**DEPARTMENT OF TRANSPORTATION
STATE OF GEORGIA**

FILE P. I. No. 0002903, DeKalb County **OFFICE** Preconstruction
STP00-0002-00(903)
Clairmont Road Sidewalks in two Phases **DATE** February 22, 2008

SUBJECT APPROVED PROJECT CONCEPT REPORT

PROJECT CONCEPT REPORT

TYPICAL SECTION

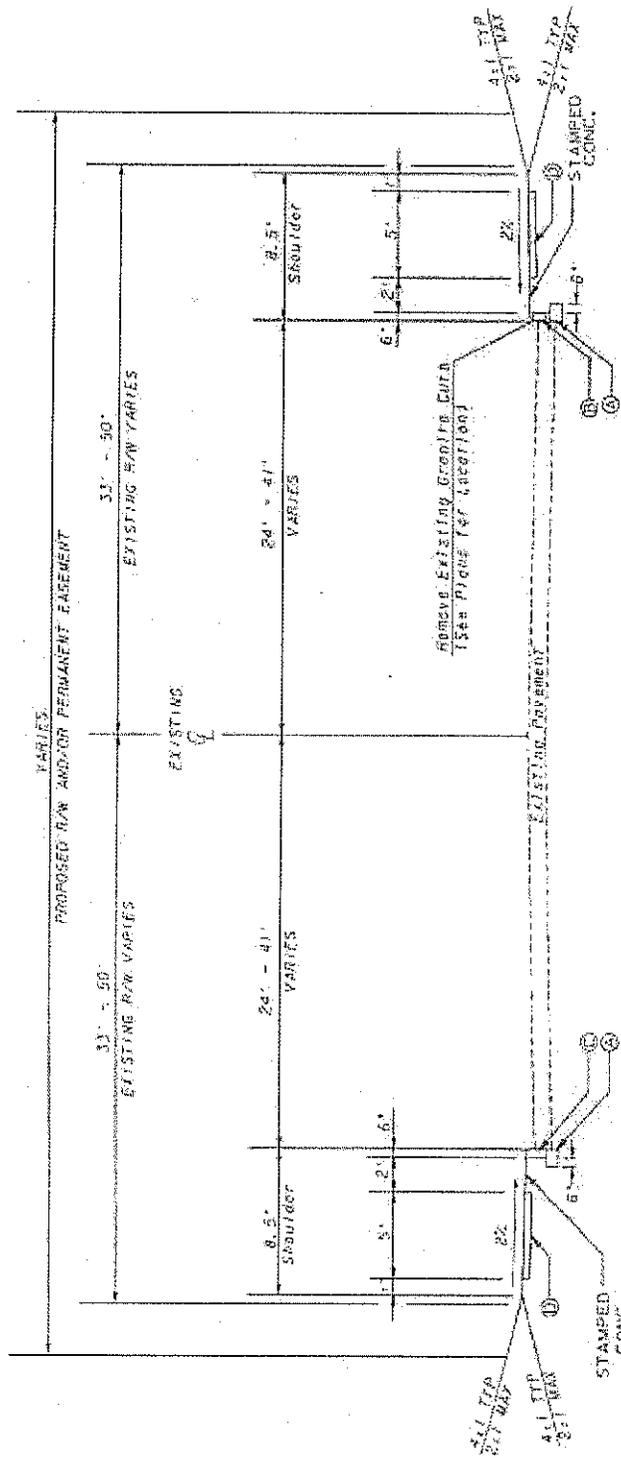
On the typical section:

- use stamped concrete in lieu of the two-foot grass strip (for quantity/cost calculations, use seven-foot wide sidewalk to cover sidewalk and strip)
- delete the two-foot widening in front of the granite curb
- change concrete curb and gutter to concrete header curb
